FROM: Bill McDow
Transportation Planning

■ **WILMINGTON MUNICIPAL GOLF COURSE [TRC Plan Review]**

🌀 Initial Review Note 🌀

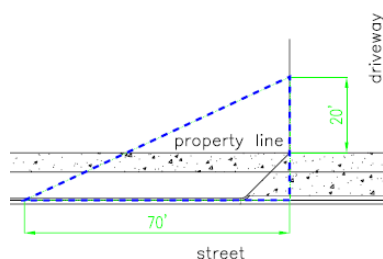
- Revise all sheets to accurately reflect the Drawing Scale for these plans. The site plans show a 1"=100' graphic scale, however, the drawing size appears to be 1"=40'. Please revise all plan sheets.
- Show the intersection of Donald Ross Drive and Pine Grove Drive.
- Please verify the maintenance status and SR number for Donald Ross Drive. The site plans show SR 1492 on Pine Grove Drive and Donald Ross Drive. Donald Ross Drive appears to be a city maintained street and not a NCDOT Maintained State Road.
- Show the intersection of Donald Ross Drive and Oleander Drive.
